ADDENDUM 001

BID# 14MOT26

Firebaugh High School HVAC Units Replacement at

Administration/Library and Gym Buildings – DSA #03-125870

PROJ. NAME	HVAC REPLACEMENT FIREBAUGH HIGH SCHOOL	APPROVAL STAMP
DSA #	03-125870	
CCD #	001	
DATE	04/2026	
PSE JOB #	2025-131	
TITLE	PARITAL PLAN S501

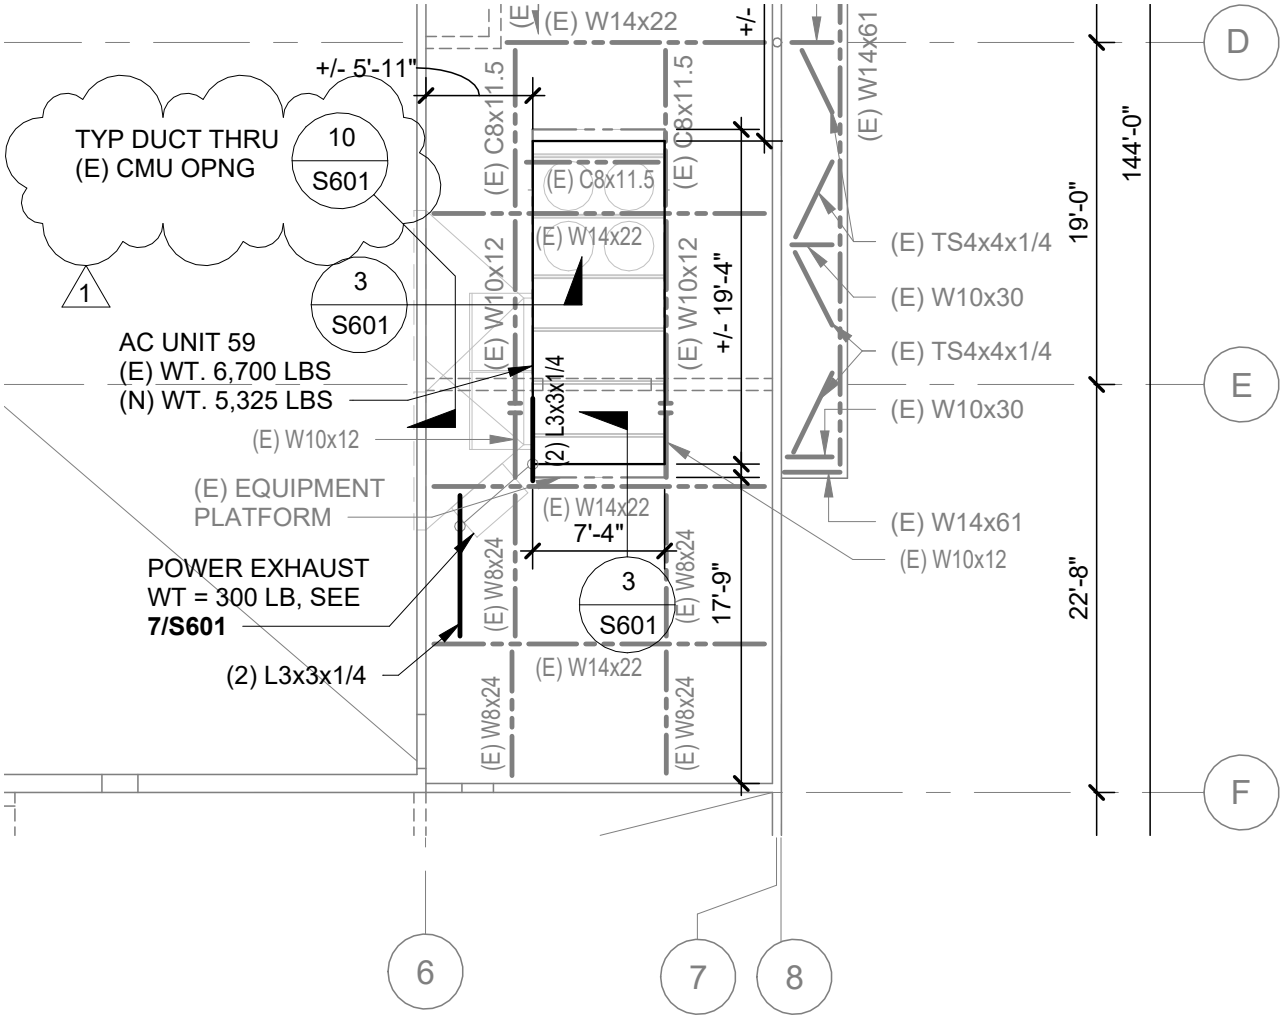
1.1-1. Reference to Sheet **FRAMING PLAN S501**

1.1-2. See attached **PARTIAL FRAMING PLAN S501 ADD01**

1.1-2.1. Revise **FRAMING PLAN S501ADD01,** to include a (N) ducts work pr attachment.

PROJ. NAME	HVAC REPLACEMENT FIREBAUGH HIGH SCHOOL	APPROVAL STAMP
DSA #	03-125870	
CCD #	001	
DATE	04/2026	
PSE JOB #	2025-131	
TITLE	NEW DETAIL 9/S601

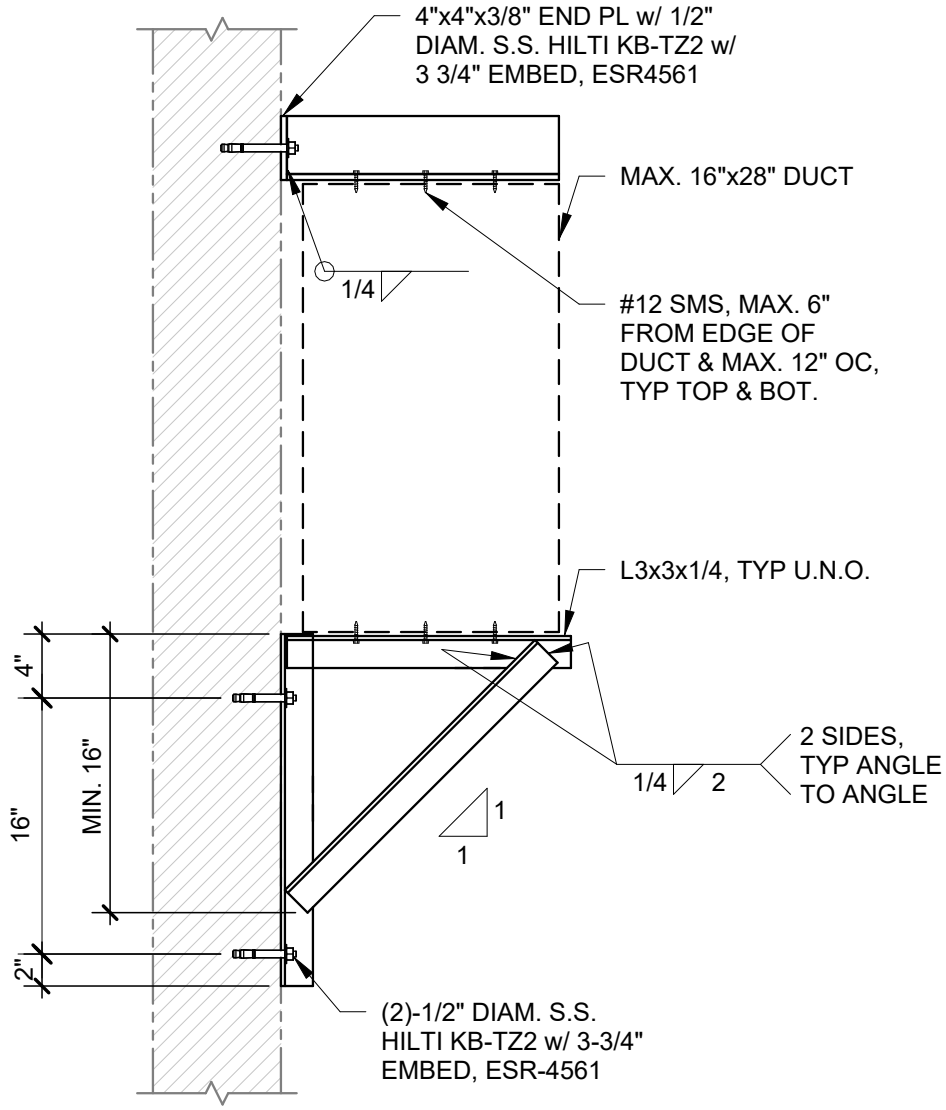
1.1-2.2. **Add new detail 9/S601 TYP DUCT SUPPORT ALONG CMU WALL,** to the construction documents, per the attachment.

NOTE:
1. PROVIDE ANGLE SUPPORTS AT MAX. 6'-0" OC.

PROJ. NAME	HVAC REPLACEMENT FIREBAUGH HIGH SCHOOL	APPROVAL STAMP
	DSA #	03-125870	
	CCD #	001	
	DATE	04/2026	
	PSE JOB #	2025-131	
	TITLE	NEW DETAIL 10/S601

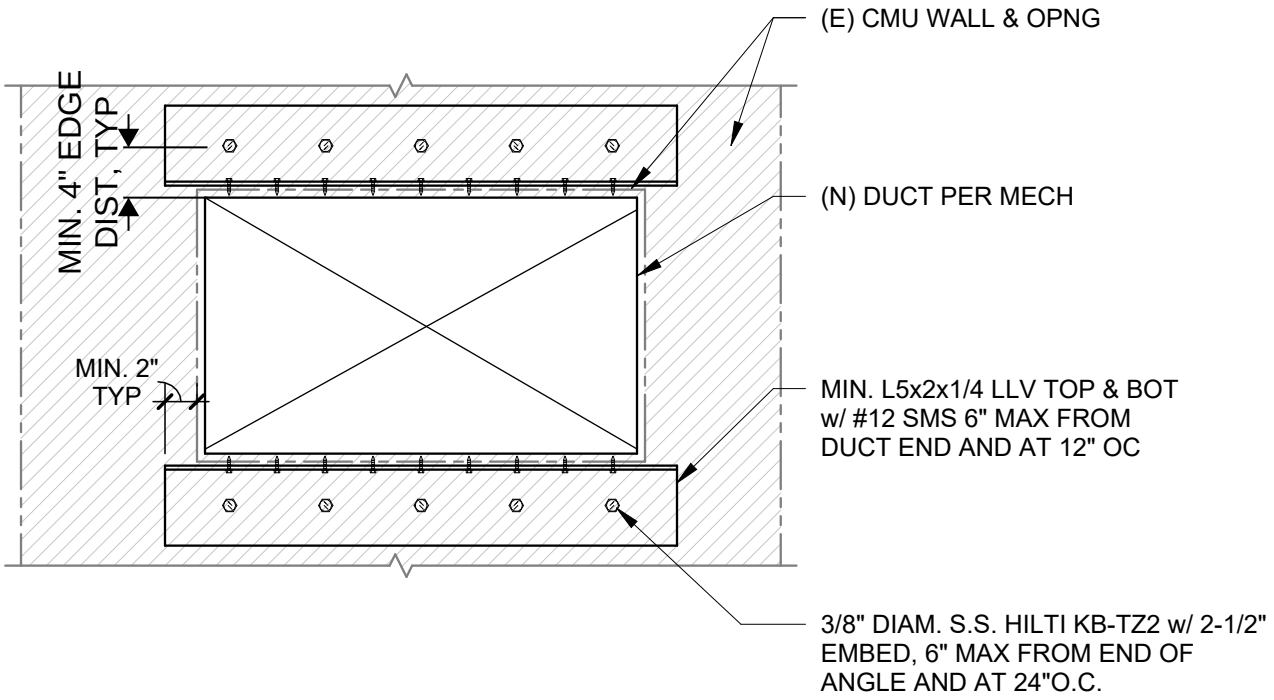
1.1-2.3. **Add new detail 10/S601 TYP DUCT SUPPORT AT CMU WALL,** to the construction documents, per the attachment.

PROJ. NAME	HVAC REPLACEMENT FIREBAUGH HIGH SCHOOL	APPROVAL STAMP
	DSA #	03-125870	
	CCD #	001	
	DATE	04/2026	
	PSE JOB #	2025-131	
	TITLE	NEW DETAIL 11/S601

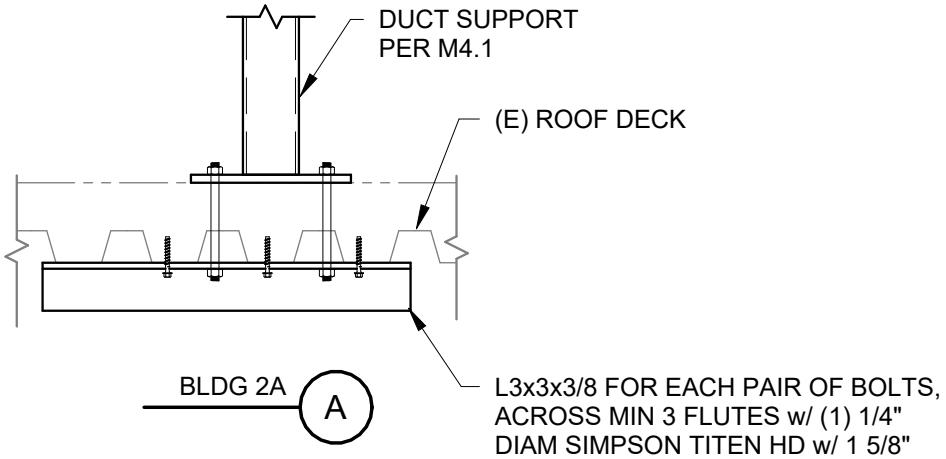
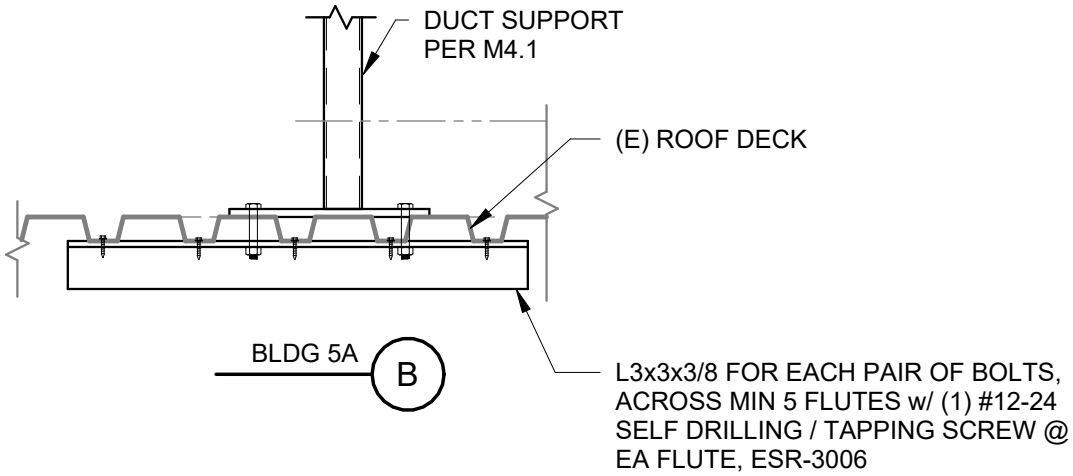
1.1-2.4. **Add new detail 11/S601 TYP DUCT SUPPORT BASE DETAIL,** to the construction documents, per the attachment.

PROJ. NAME	HVAC REPLACEMENT FIREBAUGH HIGH SCHOOL	APPROVAL STAMP
	DSA #	03-125870	
	CCD #	001	
	DATE	04/2026	
	PSE JOB #	2025-131	
	TITLE	PARTIAL PLAN M3.1

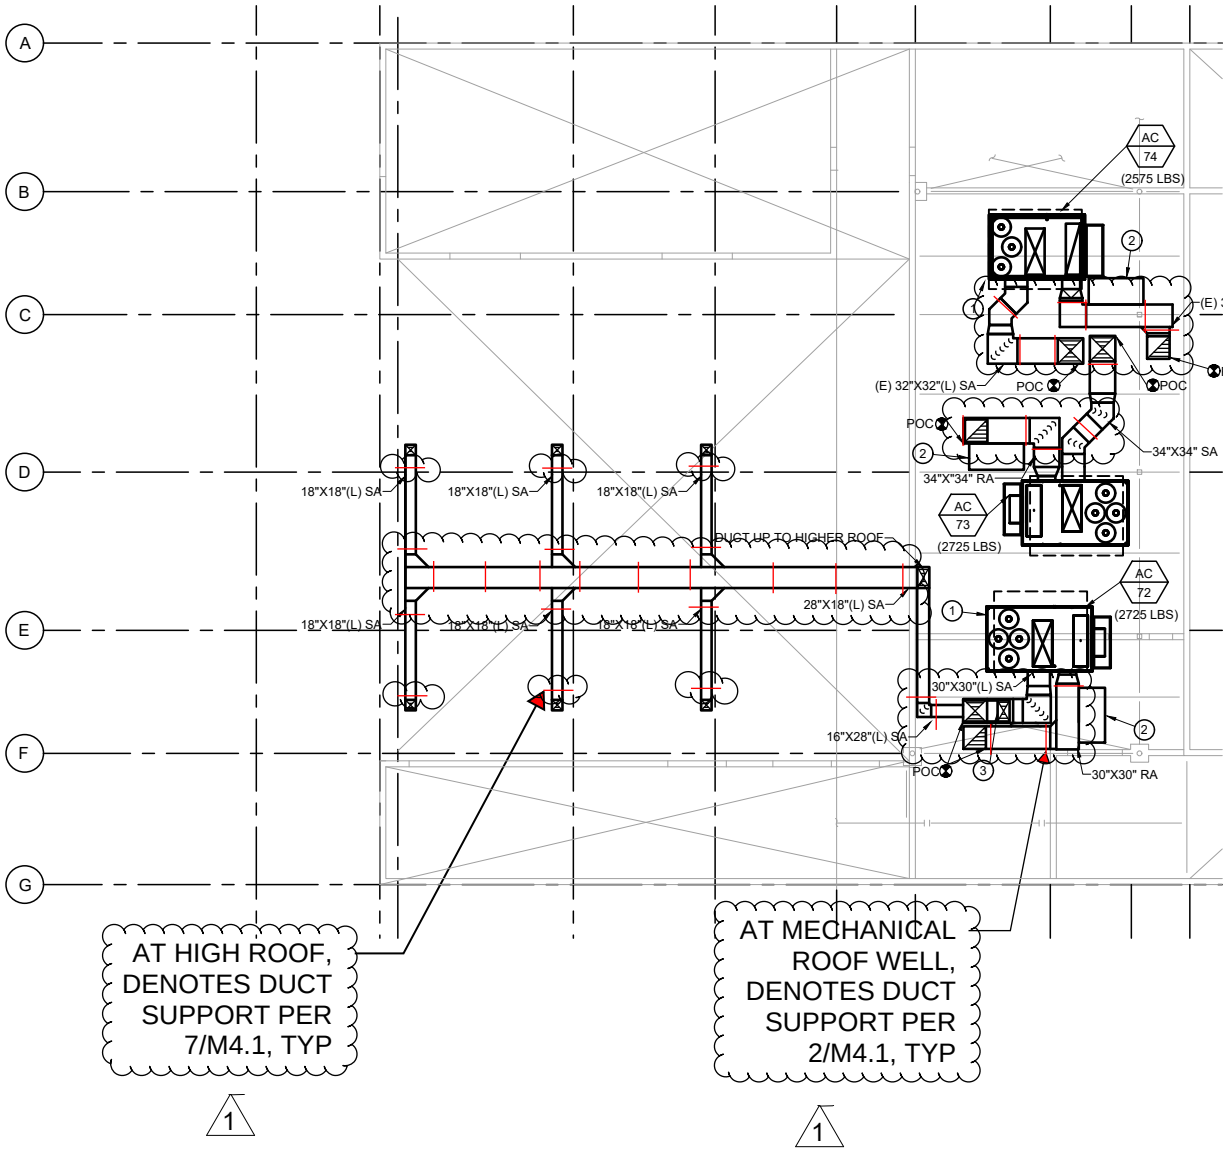
1.2-1. Reference to Sheet **BUILDING 2A CONSTRUCTION ROOF PLAN M3.1**

1.2-2. See attached **PARTIAL BUILDING 2A CONSTRUCTION ROOF PLAN M3.1 ADD01**

1.2-2.1. Revise **PARTIAL BUILDING 2A CONSTRUCTION ROOF PLAN ADD01,** to include a (N) ducts work pr attachment.

PROJ. NAME	HVAC REPLACEMENT FIREBAUGH HIGH SCHOOL	APPROVAL STAMP
DSA #	03-125870	
CCD #	001	
DATE	04/2026	
PSE JOB #	2025-131	
TITLE	REVISED DETAIL 2/M4.1

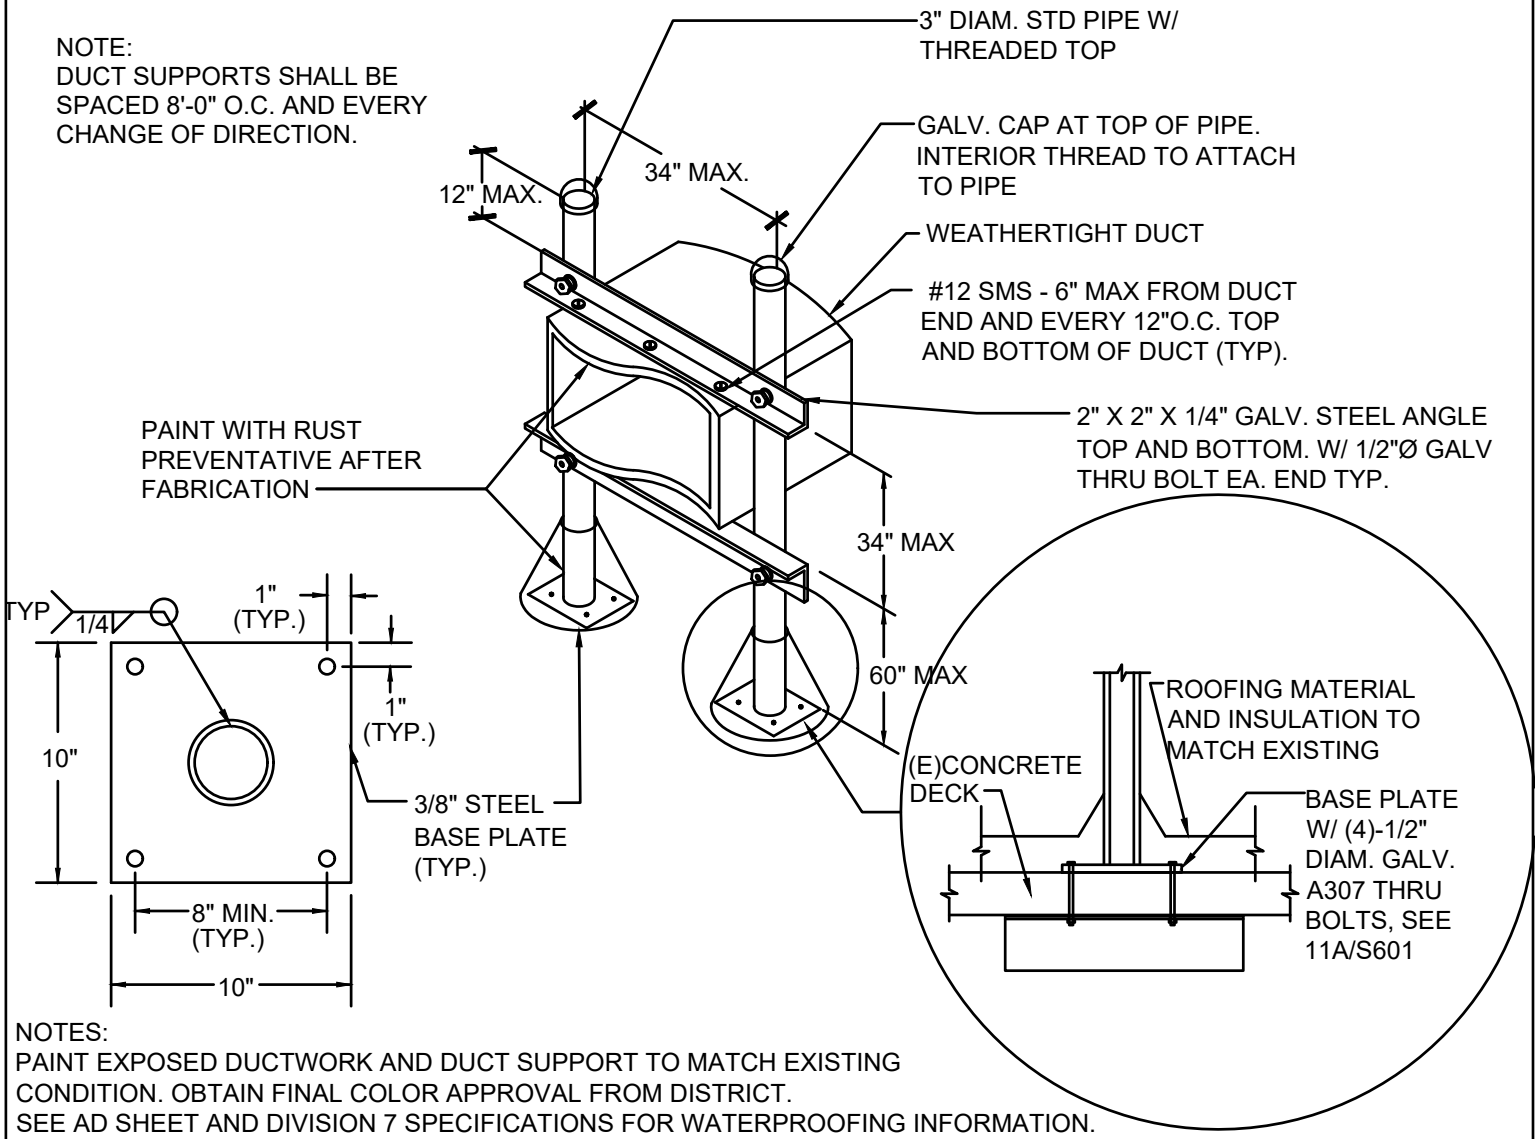
1.2-2.2. **Revise detail 2/M4.1 SUPPORT FOR RECTANGULAR DUCT ON ROOF FOR BLDG 2A (CONC OVER METAL DECK),** per attachment.

NOTE:
DUCT SUPPORTS SHALL BE SPACED 8'-0" O.C. AND EVERY CHANGE OF DIRECTION.

PROJ. NAME	HVAC REPLACEMENT FIREBAUGH HIGH SCHOOL	APPROVAL STAMP
DSA #	03-125870	
CCD #	001	
DATE	04/2026	
PSE JOB #	2025-131	
TITLE	NEW DETAIL 7/M4.1

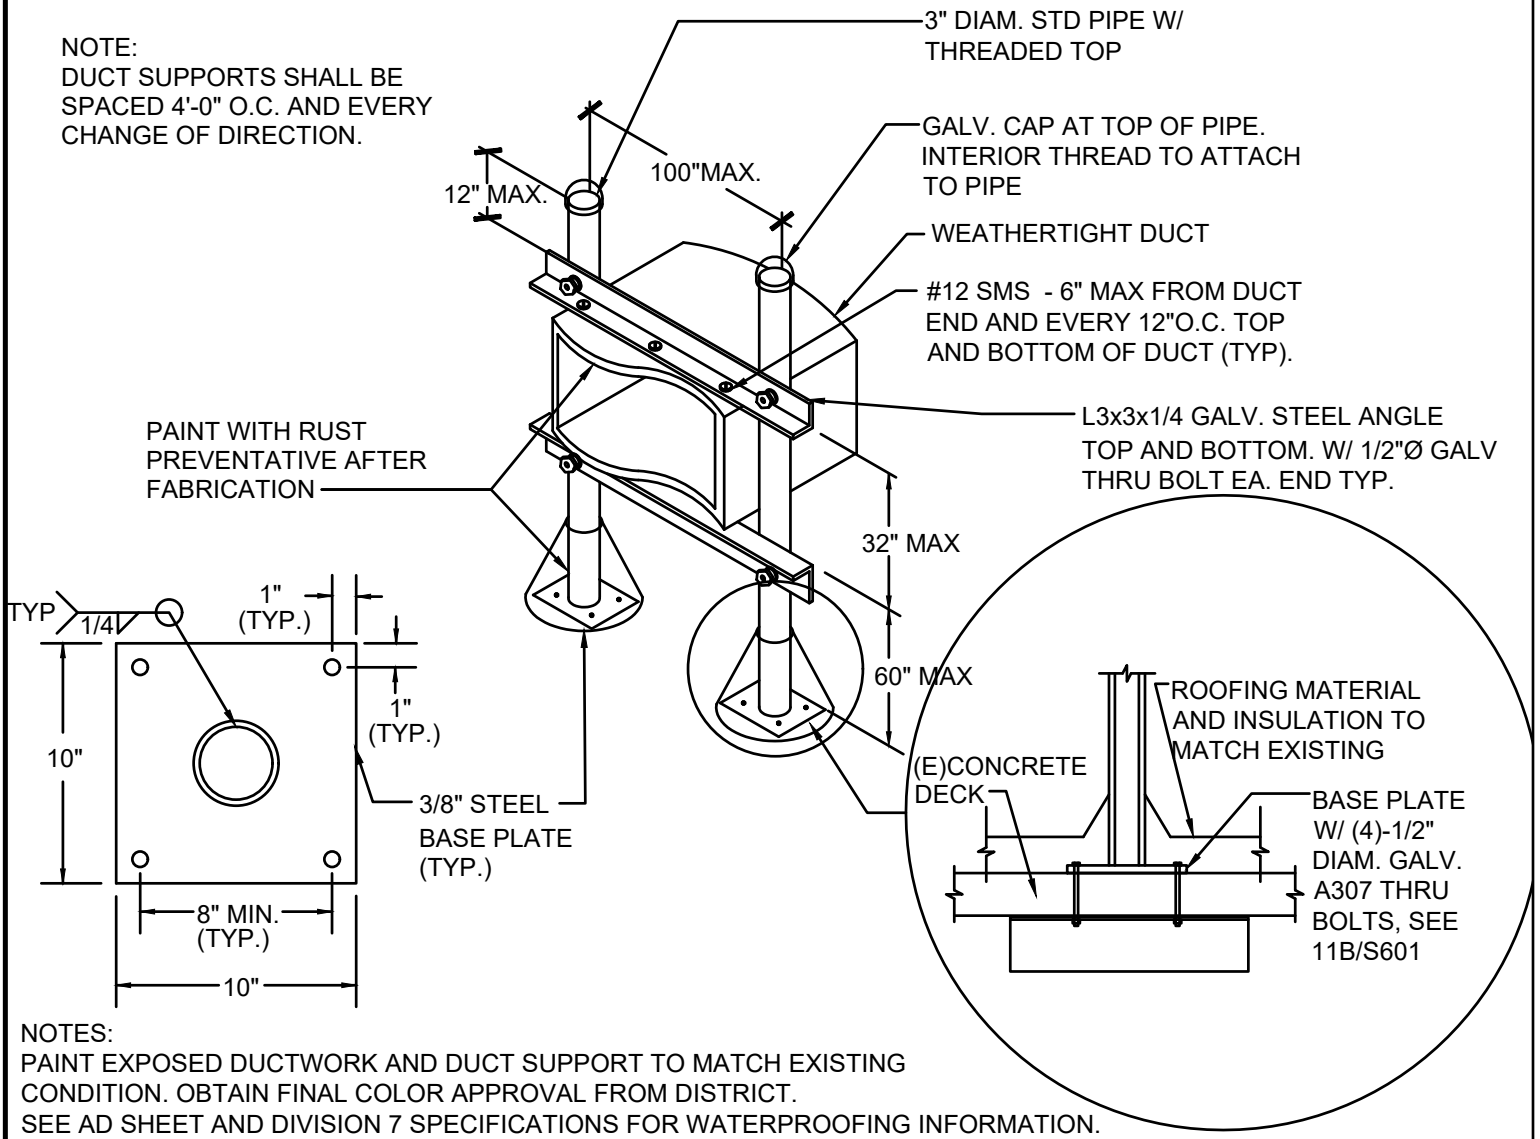
1.2-2.3. **Revise detail 7/M4. SUPPORT FOR RECTANGULAR DUCT ON ROOF FOR BLDG 5 (1-1/2" 16 GA METAL DECK)**, per the attachment.

NOTE:
DUCT SUPPORTS SHALL BE SPACED 4'-0" O.C. AND EVERY CHANGE OF DIRECTION.
